RADAR TYPE SG1 AND PANEL L18.

The following is an extract from a report by P.R.A.D.O. Auckland on modifications to enable panel L18 to be used with Type SG1 Radar in H.M.N.Z.S. GAMBIA.

FIG. 1B

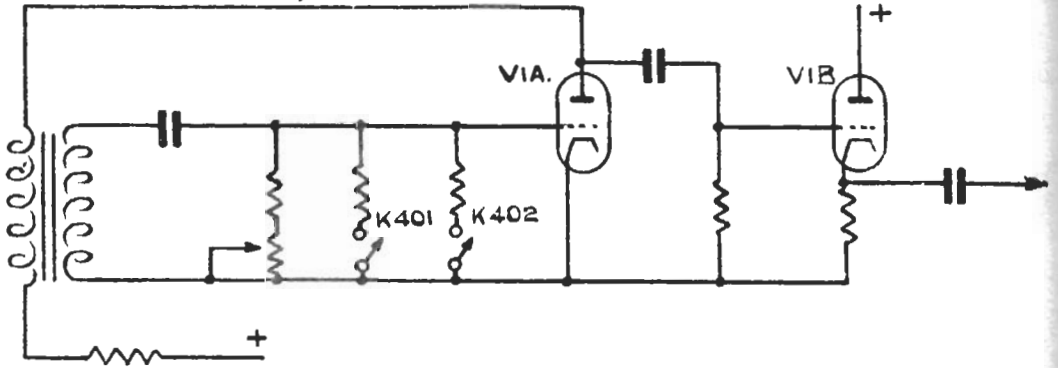
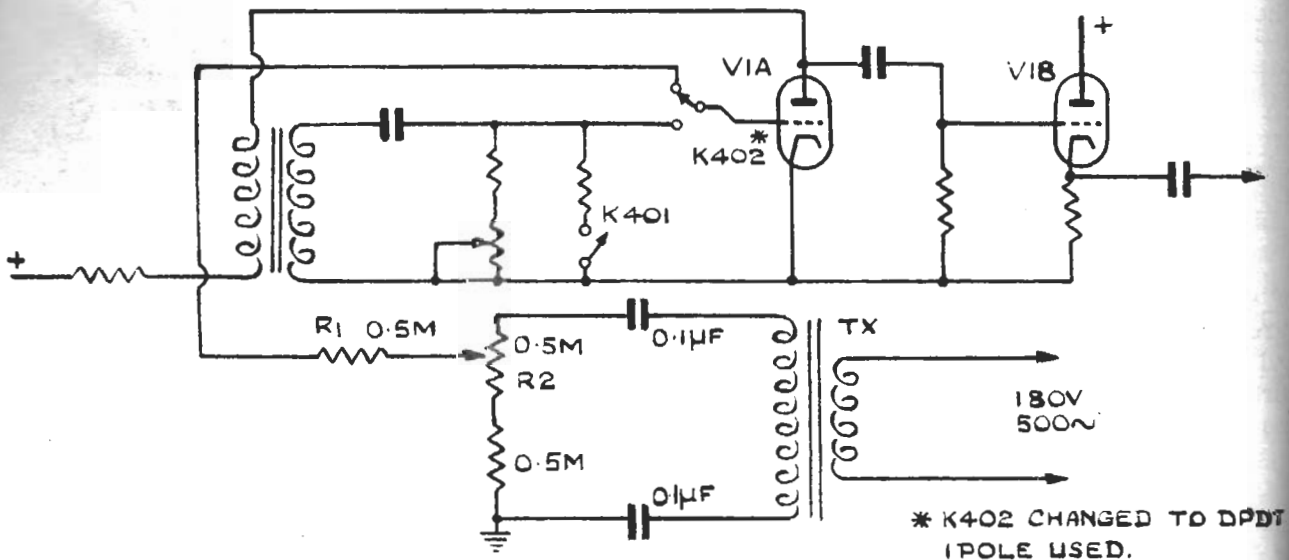
The circuit arrangement employed is shown in diagram 1 B on page 28. Diagram 1 A shows the Type SG1 oscillator before modification. Relay K402 was removed from the circuit and two position relay substituted which changes over the oscillator grid circuit from normal to panel L18 locking. It was found that at the normal power supply voltage of 180 volts applied to the grid, the output wave of V1A was insufficiently steep-fronted to provide stable locking. The transformer Tx which develops approximately 600V across the secondary was added, this produces the necessary sharp leading edge output wave of sufficient amplitude and provides stable locking. Grid stopper R1 of .5 megohm protects the valve during positive half cycles of locking voltage. R2 is adjusted to produce stable locking voltage, the required value is about 400 volts. It is necessary to watch the phasing of the 500 cycle locking voltage as in the standard panel L18 - Type 272 arrangement."

This is a very useful modification. It is suggested that the ranging panel L17/18 should be modified in the same way as when used with Type 284, (see C.A.F.O. 1755/43). The reduced time base length will make the ranging panel less susceptible to slight phase discrepancies. It is presumed that potentiometer R2 has an effect on the phase relationship.

The voltage applied to the grid of valve V1A is large but it is probable that the valve can accept it. Ships carrying out this modification should check that the valve life remains reasonable.

RMR (1) TYPICAL LAYOUT FOR CRUISERS & ABOVE
-MINUS TYPE 262

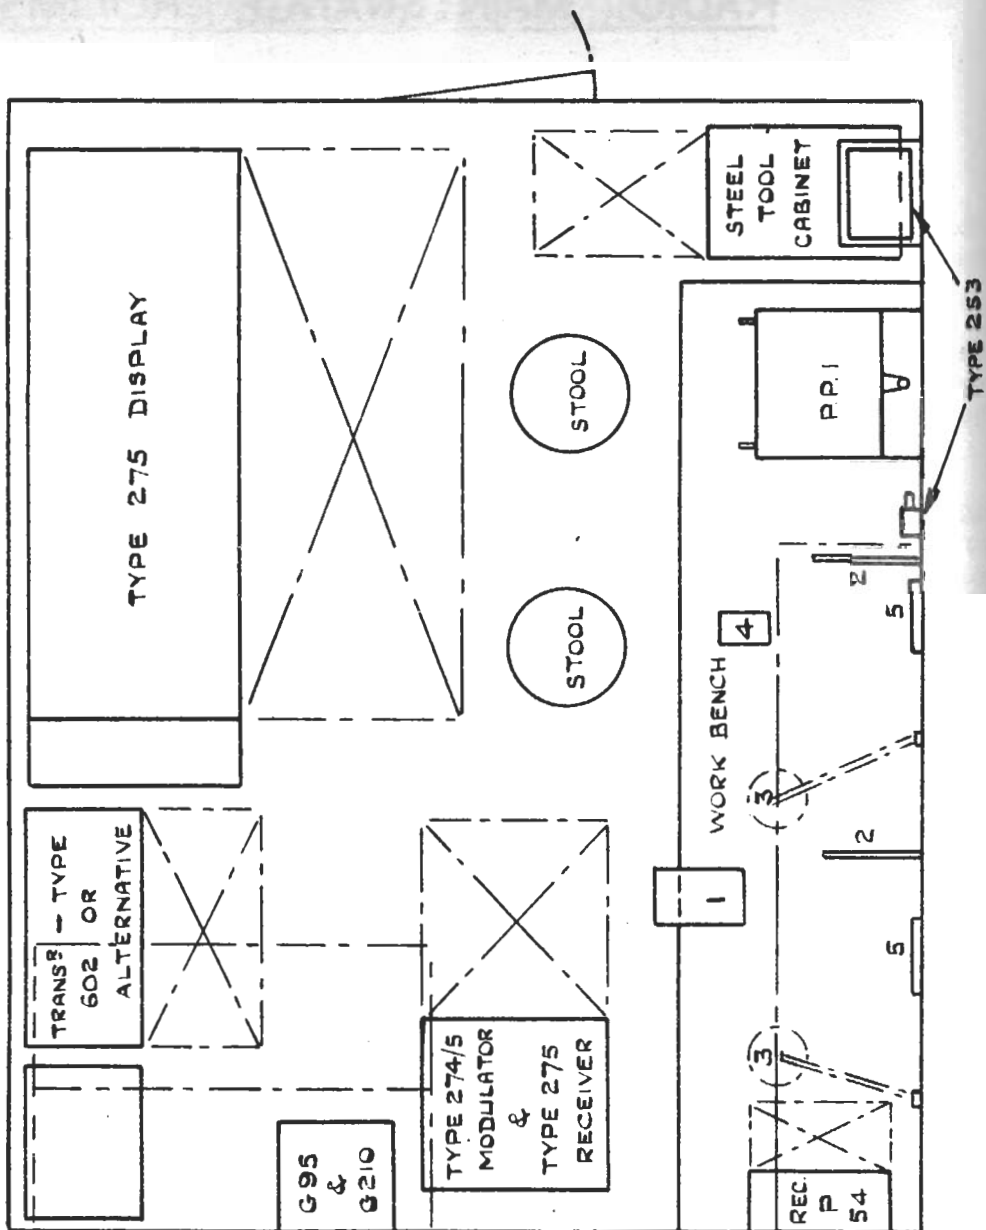
This order is being re-issued to give fuller details of the Type 275 equipment provided and to clarify the instructions to Commanding Officers which are somewhat obscure in the original order.

The accompanying layout drawings are extracted from Installation Specification B and will assist ships' officers in formulating proposals for the siting of R.M.R's.

" TYPE 242 AERIAL ARRAY.

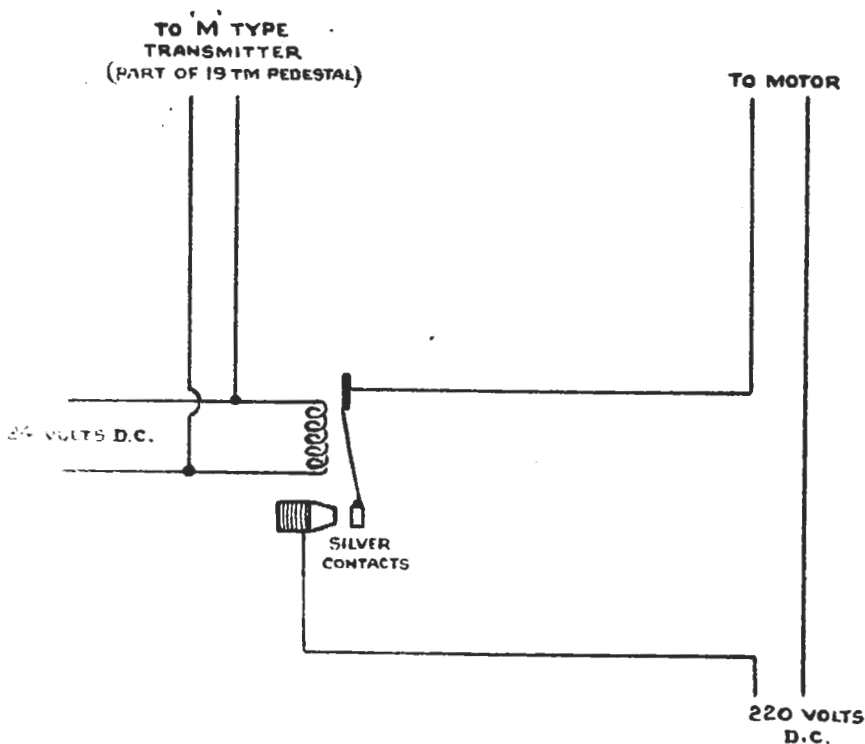
A considerable amount of trouble has been experienced with pedestal unit 19 T.M., part of Type 242 aerial array, with 400° rotation. During 18 months in service, the same defect has twice occurred and consists in the key, normally fitted into the keyway in the upright part of the pedestal, becoming adrift due to the holding bolts shearing when the spring loaded stop comes into action. When this defect occurs a block and tackle has to be rigged and the whole pedestal lowered on to the upper deck. This is no easy job and takes at least 48 hours to complete.

To overcome this defect the following system has been used. A relay operating in parallel with the 24 volt D.C. supply has been inserted in series with one side of the 220 volt D.C. supply to the motor as shown in the diagram. Thus, if the 24 volt supply is suddenly cut off the motor will not rotate. The only occasion when the spring loaded stop will come into operation is if the Type 242 aerial is switched on when the W.S. aerials are facing astern, and even then it is considered that the aerial will not bump against its stop with the same effect as if the circuit breaker pattern 54312 was fitted.
